# STATE OF NEW HAMPSHIRE

**SUBJECT:** Dredge & Fill Application  
Dixville, 42398  
NHDES # 2019-012335

Included and enclosed are responses and additional information to address the request for more information letter dated July 11, 2019 and received by NHDOT on July 15, 2019 for the subject NHDOT Bureau of Bridge Maintenance project in the town of Dixville, NH along NH Route 26 over Flume Brook. In accordance with NHDES' and NHDOT's LEAN agreement the following responses are numerated analogously to the RFMI letter. The RFMI required plan revision which constitutes this as a level 2 RFMI and under the RFMI LEAN agreement NHDOT has 30 days to respond and DES has 7 days from a complete RFMI response to issue the permit. Goal of the LEAN event was to factor the RFMI process into the 89 day timeframe. The RFMI letter came 18 days prior to the target date.

STATE OF NEW HAMPSHIRE									
DEPARTMENT OF TRANSPORTATION * BUREAU OF BRIDGE MAINTENANCE									
TOWN		DIXVILLE		BRIDGE NO.		206/101		STATE PROJECT 42398	
LOCATION NH 26 OVER FLUME BROOK									
WETLAND IMPACT PLAN								BRIDGE SHEET	
REVISIONS AFTER PROPOSAL				BY		DATE		1 OF 3	
				DESIGNED DBL		3/15/19		CHECKED	
				DRAWN

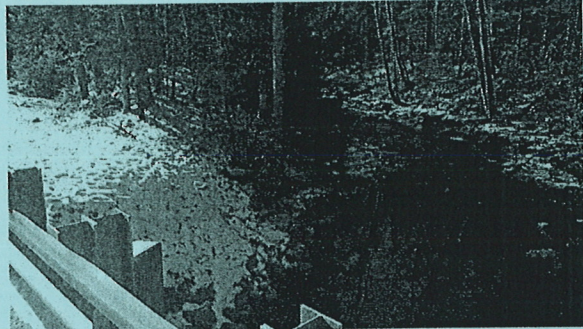
4. Attached with this response on sheet one of the revised wetland impact plans is a typical cross-section for rip-rap bank stabilization. The rip-rap size gradation was previously submitted on the wetland impact plans however a cross section was missing. Please find the attached edited 404.04 form as well for additional details such as minimum and maximum stone size, thickness, and bedding material.

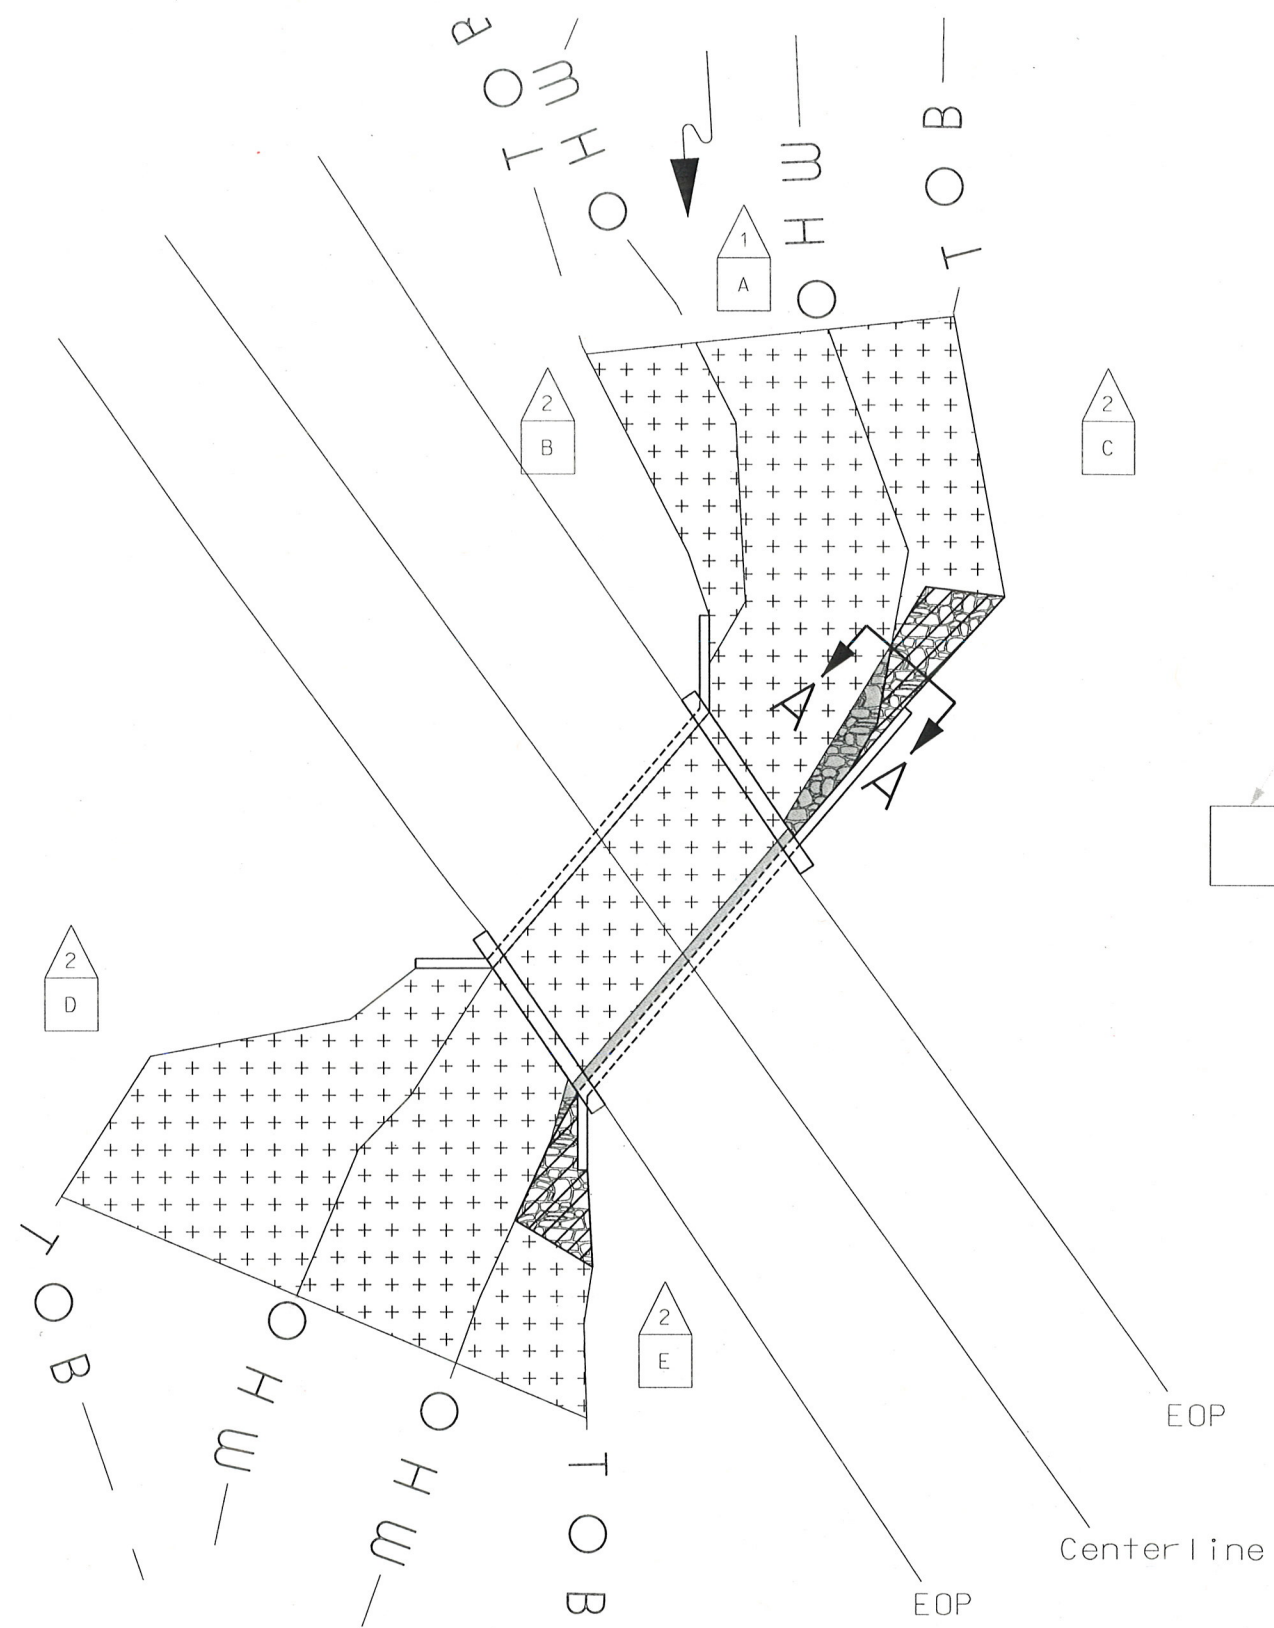
9. As indicated on the watershed map the crossing will continue to pass the streamstats Q50 storm and will accommodate the Q100 storm but will overtop at 602.54 cfs. The proposed rehabilitation work will not change the existing condition. Included are the HydroCad calculations that determined this.

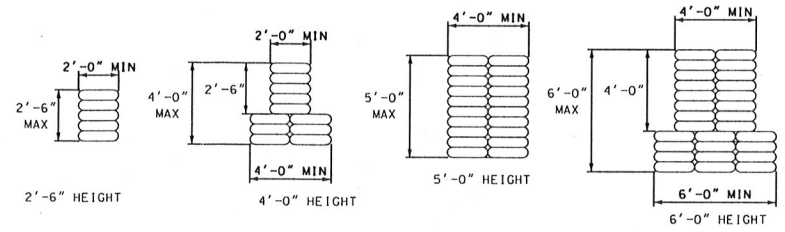
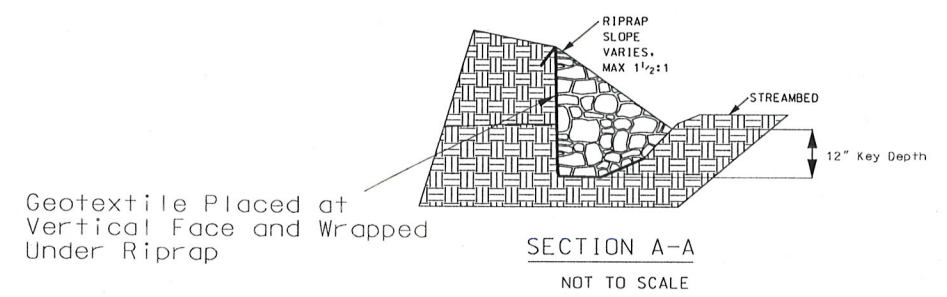
- a. The proposed rehabilitation work will not change the inlet and outlet invert elevations. A note indicating this was added to the impact plans. (*\*Per NHDES' and NHDOT's RFMI LEAN event for Operations project NHDOT will include existing and proposed contours as well as structure invert elevations on plans when possible.*)
- b. See impact plan for area of impact associated with rip-rap installation. Riprap will be placed where riprap currently and previously existed. Attached are two additional photos showing riprap along the river left bank.

- c. See impact plan. Labels for the road center line and edge of pavement (EOP) have been added to the impact plans.
6. NHDOT Wetlands Program classified Flume Brook as a R3UB12 – Riverine, Upper Perennial, Unconsolidated Bottom, Cobble Gravel & Sand wetland system based on site conditions observed during the wetland delineation. Streambed materials at the inlet, outlet, and through the structure can be seen in the photos provided with the application submittal and the above additional photos.

\*Note: Contours in areas of permanent channel and bank impacts, will be brought back to existing condition.

The inlet and outlet inverts will not change as a result of the proposed rehabilitation and scour protection work.

All work will be completed with the NHDOT ROW.

RIPRAP GRADATION  
D15 < 16"  
D50 < 21"  
D100 < 36"
